Rover Service News Letter No. 103

May 1959

TO ALL DISTRIBUTORS AND DEALERS

Fig. 2.

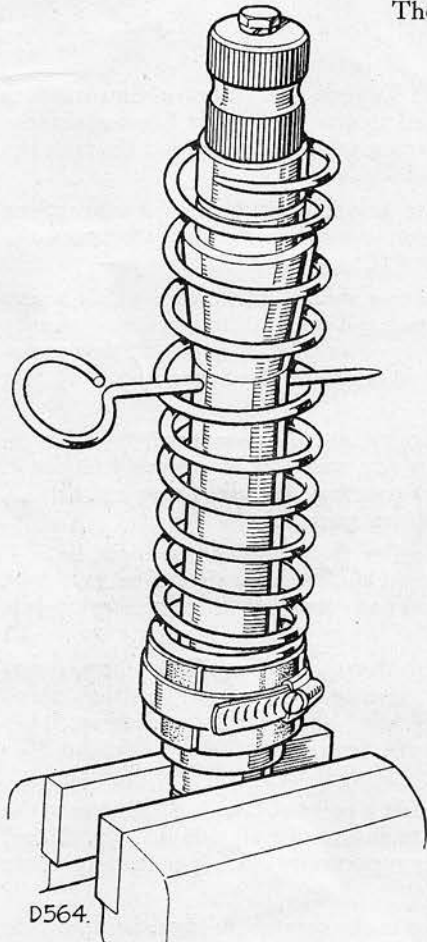
An improved and safer method of fitting the spring to the steering relay unit is now available; this is a hardened steel pin in place of the clips previously used. The pin should be used as detailed below:—

1. Examine all parts and renew as necessary.
2. Fit the top end plate and joint washer to the housing.
3. Fit one split bush to the taper on the bottom end of the shaft, and secure tightly with a suitable 2 in. hose clip (Part No. 50323).

4. Place a steel washer on to the shaft, next to the inner side of the Tufnol bush.
5. Place the spring over the shaft and insert the special tool (Part No. 510309) through the coils of the spring and right through the lubrication cross-drilling in the shaft.

6. The spring can now be wound down the tool until the steel washer and the split Tufnol bush can be secured to the taper on the other end of the shaft with a hose clip.

7. Remove the special tool (Part No. 510309).
8. Place a brass thrust washer on the top end of the shaft, lubricate the shaft and insert into the housing.

9. With a plastic hammer gently tap the shaft into the housing until the first hose clip slides off the Tufnol bush, remove the clip completely from the shaft.

10. Continue to tap the shaft into the housing until the second clip is freed and the shaft abuts the top end cover.
11. Fit the bleed and filler plugs, fill the unit with oil, replace the bottom end thrust washer, joint washer, end cover and tighten the retaining bolts.

12. Fit the upper relay lever.
13. If the unit is in order, it should require a force of at least 12 lb. (5,5 kg.) to turn the relay shaft, using a spring balance in the relay lever boss.
